**PLANNED UNIT DEVELOPMENT
& SUBDIVISION STAFF REPORT****Date: May 18, 2017****DEVELOPMENT NAME**

Providence Park Mob1 Subdivision

Planned Unit Development Approval to amend a
previously approved Planned Unit Development Master
Plan to allow a medical office, and Subdivision approval to
create one legal lot of record.

SITE PLAN

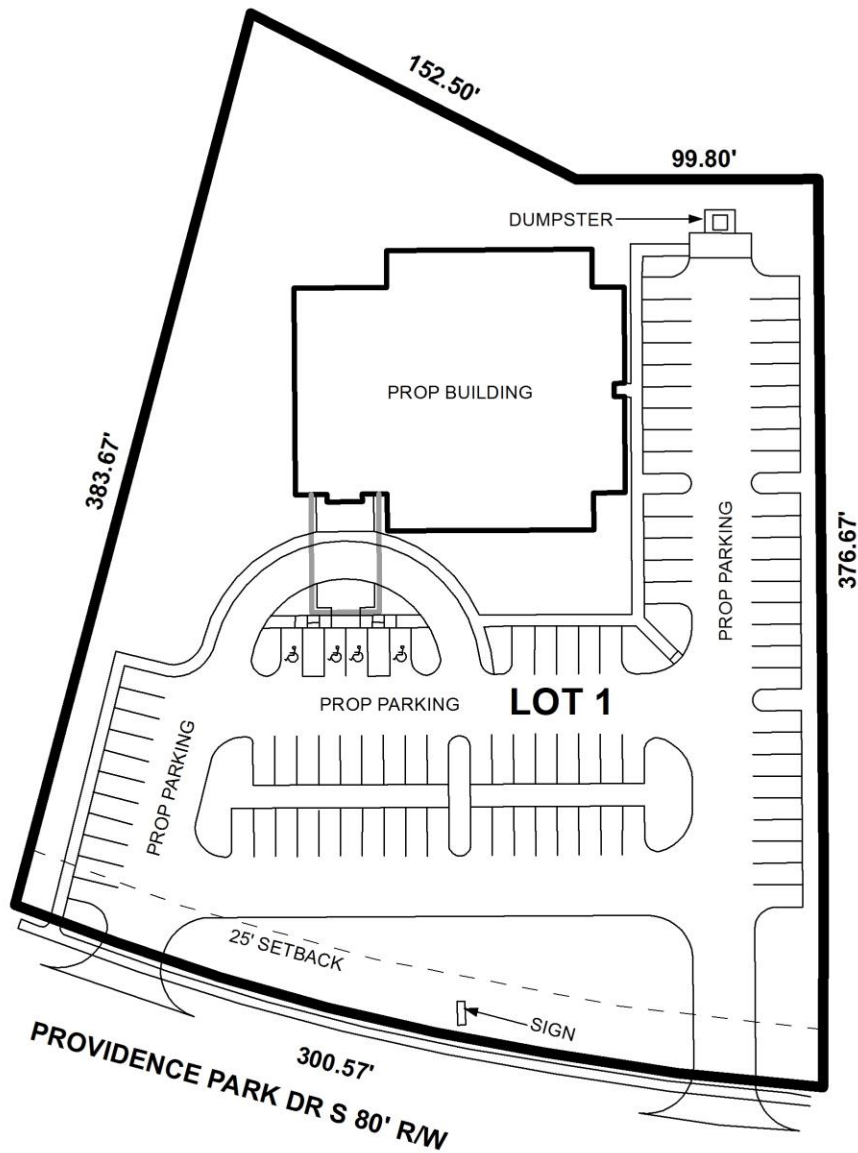
The site plan indicates a proposed single-story 14,050 square-foot medical clinic with associated parking. Parking calculations are erroneously broken into office and examination room ratios which provide for 84 parking spaces which is actually more than the required number for the use. This calculation should be revised to be based on the total square footage of the clinic (14,050) divided by 300, in which the correct minimum number required would be 47. It should be noted that, since the site will have more than 25 parking spaces, a photometric lighting plan for the parking lot will be required at the time of submittal for development permits.

Landscaping calculations indicate compliance with the ratio requirements. However, no tree planting calculations are provided. Therefore, the site plan submitted for permitting should be revised to provide tree planting calculations and indicate tree planting compliance.

Two 24' wide curb cuts are proposed which would be allowable for the lot frontage. The size, location and design of all curb cuts are to be approved by Traffic Engineering and conform to AASHTO standards. A Traffic margin note on the site plan references an existing curb cut to McVay Drive and this should be corrected and the note should contain the current Traffic Engineering comments.

- 1) retention of the 25' minimum building setback line on the site plan;
- 2) revision of the parking calculations to be based on one parking space for every 300 square feet of gross building floor space (14,050 square feet) to require a minimum of 47 parking spaces;

- 3) retention of the lot size label in both square feet and acres, or the furnishing of a table on the site plan providing the same information;
- 4) revision of the site plan to provide tree planting calculations and indicate tree planting compliance;

- 5) placement of a note on the site plan stating that the site is limited to two curb cuts to Providence Park Drive South, with the size, location and design of all curb cuts to be approved by Traffic Engineering and conform to AASHTO standards;

- 6) correction of the Traffic note on the site plan to not refer to McVay Drive and to contain the Traffic Engineering comments;
- 7) *subject to the Engineering comments: [ADD THE FOLLOWING NOTES TO THE PUD SITE PLAN: 1. Any work performed in the existing ROW (right-of-way) such as driveways, sidewalks, utility connections, grading, drainage, irrigation, or landscaping will require a ROW permit from the City of Mobile Engineering Department (208-6070) and must comply with the City of Mobile Right-of-Way Construction and Administration Ordinance (Mobile City Code, Chapter 57, Article VIII). 2. A Land Disturbance Permit application shall be submitted for any proposed land disturbing activity with the property. A complete set of construction plans including, but not limited to, drainage,*

As per telephone conversation with the applicant's engineer, no revisions are proposed to the Subdivision as originally presented. The PUD site plan has been revised to reflect a mirror image from the original site plan of the proposed development and to remove the proposed detention facility, other than the freestanding sign location. Certain revisions required by the original conditions for approval have been made on the site plan such as the parking calculations, tree planting calculations and the addition and correction of certain notes.

- 1) *retention of the 25' minimum building setback line on the site plan;*
- 2) *retention of the revised parking calculations;*
- 3) *retention of the lot size label in both square feet and acres, or the furnishing of a table on the site plan providing the same information;*

- 4) *retention of the tree planting calculations on the site plan;*
- 5) *retention of the note on the site plan stating that the site is limited to two curb cuts to Providence Park Drive South, with the size, location and design of all curb cuts to be approved by Traffic Engineering and conform to AASHTO standards;*
